SERVICE BULLETIN:

JSB 025-1

Subject:

Undercarriage Bolt Life

Figure 1 – Undercarriage

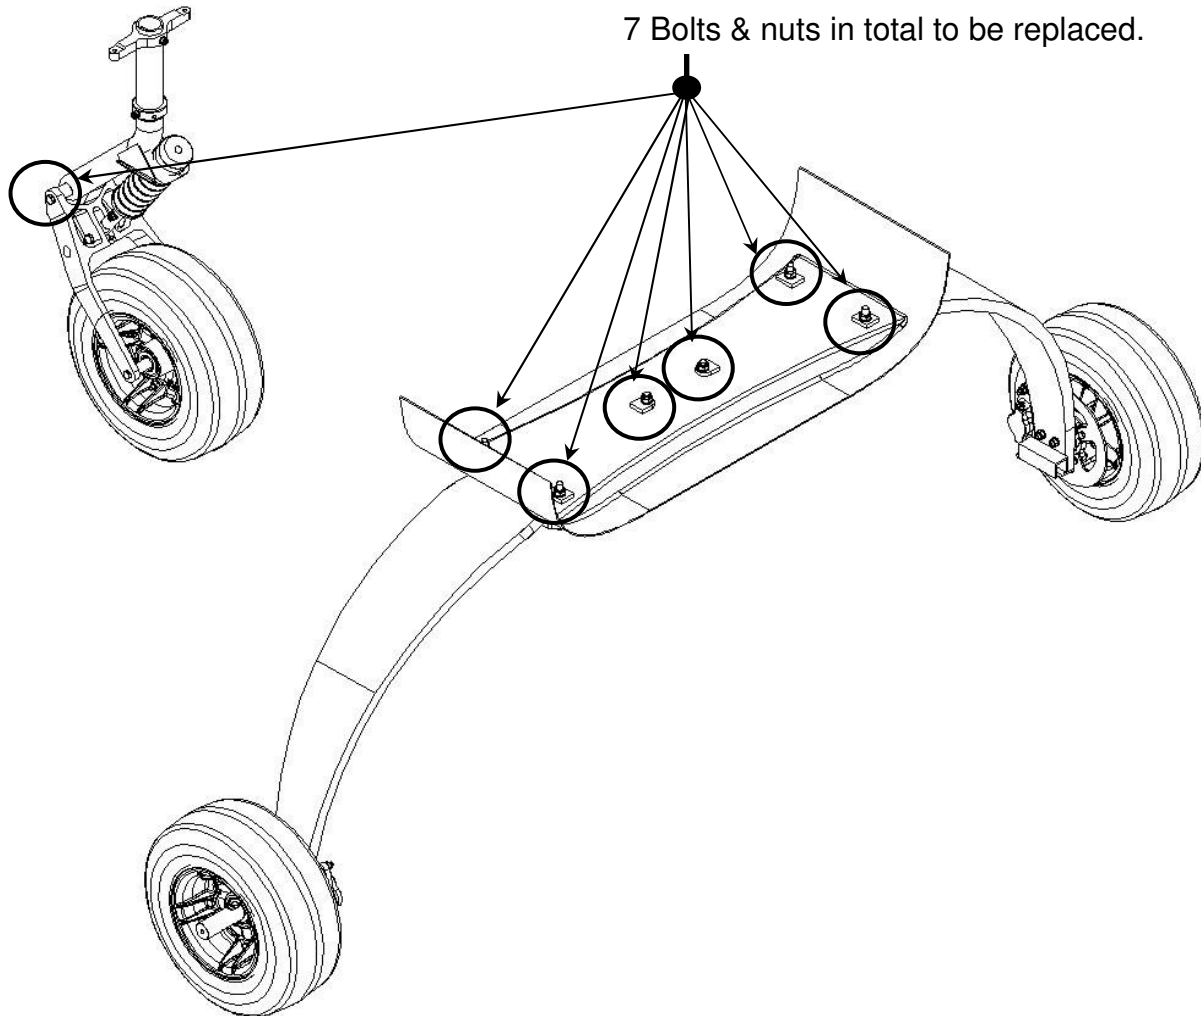
- Bolts and nuts used in the positions shown in Figure 1 are to be replaced after 500 hours Time In Service (TIS).
- Bolts which have already surpassed 500 hours TIS are to be replaced at the aircraft’s next 100-hourly or annual inspection.

- A procedure for removing the undercarriage legs is given in the Technical Manuals of all Jabiru Aircraft and is to be used for this task.
- Figure 1 shows a general schematic of a tricycle undercarriage for a Jabiru Aircraft. The bolts which are to be replaced are indicated. While there are detail differences between Jabiru models all have the same general layout and have the same critical 7 bolts which are to be replaced.

- For tail-dragger models the 6 bolts retaining the main (front) undercarriage legs are to be replaced. No specific bolts are required to be replaced at a certain TIS in the tail wheel assembly.
- The old bolts and the aircraft components are to be inspected while disassembled for indications of looseness, fretting or other damage and repaired / replaced as necessary.
